# UNITED STATES PATENT AND TRADEMARK OFFICE

10/583,901

Angelo Schiavon

### **DETAILED ACTION**

Cooper's fig 1 is copied herein. Cooper teaches a primary filter element (48), secondary (bypass) filter element (71), an end cap (5) there-between, the end cap

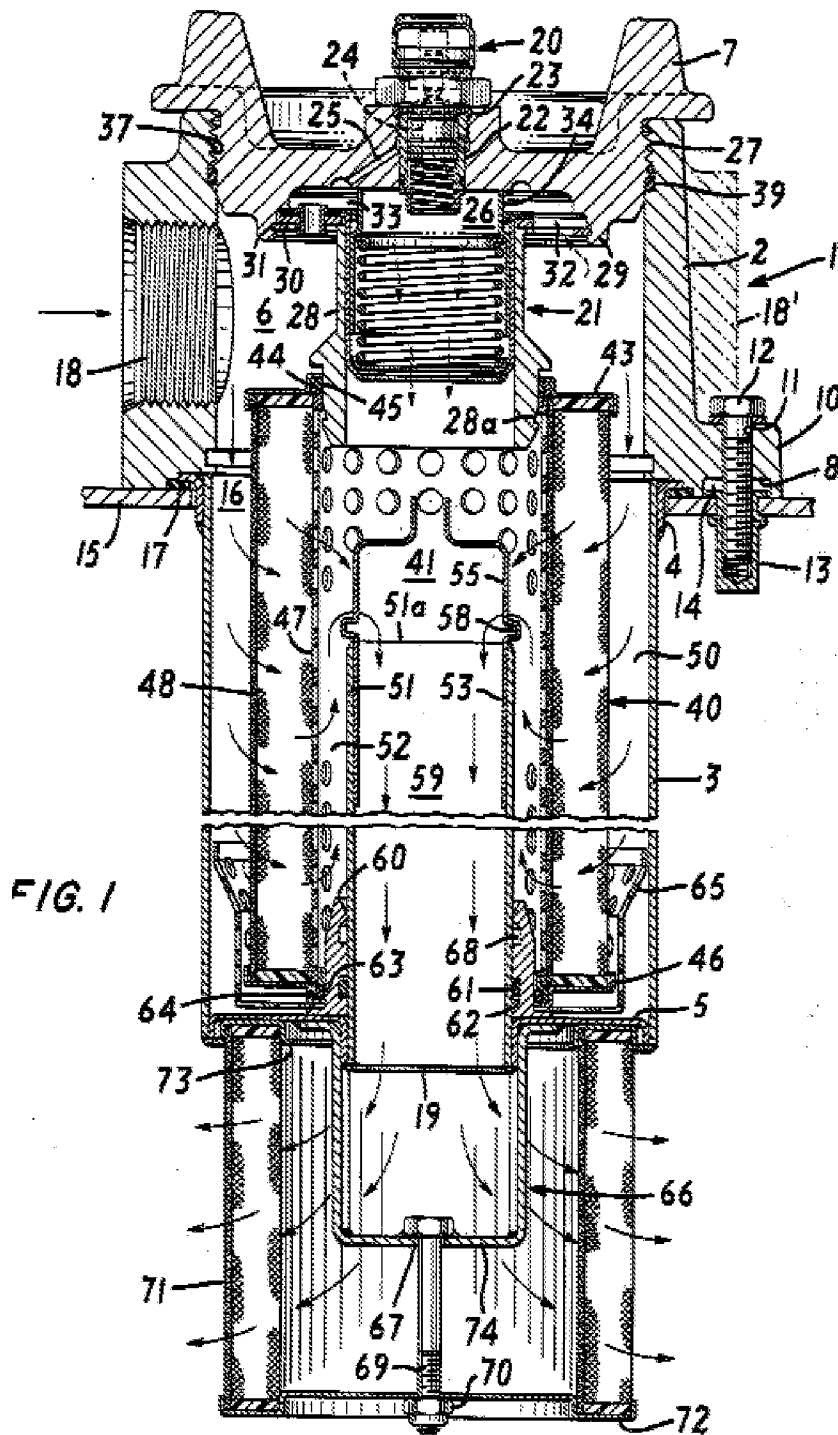
#### **1. Claims 19, 21 and 22 are rejected under 35 U.S.C. 102(b) as being anticipated by Cooper (US 4,133,763).**

having a tube (51/53) projected within and parallel to the axis, a seal (61) in a seal member surrounding the tube, a perforated tubular support within the primary filter, a second end cap at the opposite end of the primary filter (43) which has a tube extending from it for connection to the housing top, and having a seal (45) on a seal plane which is having a slight angle as can be visualized from (28a). The structural member (66) is received in a radial slot defined by the first end cap and the filter end (73).

Cooper does not teach the seal (45) at the second end cap as being at an angle to the axis. However, providing an appropriate draft angle for the seal plane at (28a) would be within the skill of one of ordinary skill in the art. In *Gardner v. TEC Systems, Inc.*, 725 F.2d 1338, 220 USPQ 777 (Fed. Cir. 1984), cert. denied, 469 U.S. 830, 225 USPQ 232 (1984), the Federal Circuit held that, where the only difference between the prior art and the claims was a recitation of relative dimensions of the claimed device and a device having the claimed relative dimensions would not perform differently than the prior art device, the claimed device was not patentably distinct from the prior art device. In re *Dailey*, 357 F.2d 669, 149 USPQ 47 (CCPA 1966) (The court held that the configuration of the claimed disposable plastic nursing container was a matter of choice which a person of ordinary skill in the art would have found obvious absent persuasive evidence that the particular configuration of the claimed container was significant.).
